#### **Project: IEEE P802.15 Working Group for Wireless Personal Area Networks (WPANs)**

**Submission Title:** [MAC attributes break down indicating interference avoidance]

**Purpose:** [To be considered in 15.3c Usage Model Document]

# MAC attributes break down indicating interference avoidance

### MAC attribute break down example #2 (UM2 case)

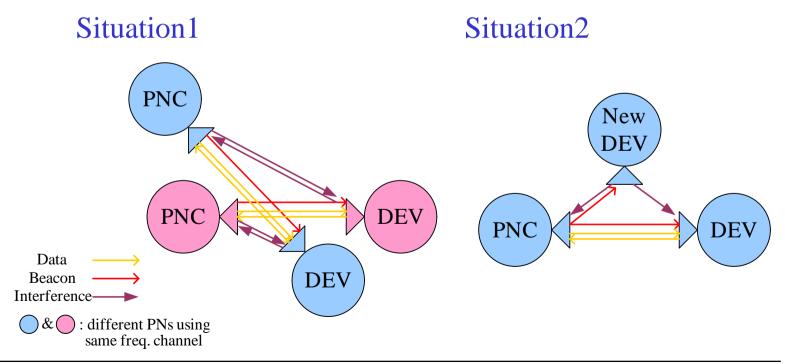
■ UM2 as well as UM3 and 4 needs device discovery.

U M	Use Case	Usage	MAC- SAP	Equivalent 'Usage' in current description [Usage #]	Current attributes (for reference)	Edited MAC Related Systems Attributes
Optional	2	U1/U3	Uncompressed video streaming 1080i, 24, 60	0.62Gbps (0.497Gbps w/o Blk.)	Uncompressed HDTV Video/Audio streaming [DVD players and other power-line operated devices] [1]	a) Isochronous b) High throughput efficiency c) Point-to-Point d) Support for high gain antennas for Data Transmission e) Device discovery f) Moderate latency g) Minimum reserved bandwidth	a) Isochronous b) High throughput efficiency c) Point-to-point d) Support for high gain antenna for data transmission d-1) Interference avoidance d-2) Device discovery e) Moderate latency f) Minimum reserved bandwidth  MAC attribute break down

## Necessary managements in situation1

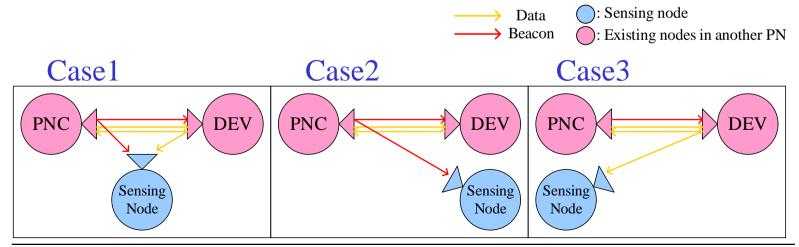
- A PN should allocate a channel after confirming every node in the PN is NOT under 'interference cases' with that channel.
- Possible 3 interference cases should be watched out, when outer PNC or DEV in another PN are existing.
  - Case 1: Beacons from PNC and Frames from DEV are heard.
  - Case2: Beacons from PNC but not Frames from DEV are heard.
  - Case3: Frames from DEV but not Beacons from PNC are heard.
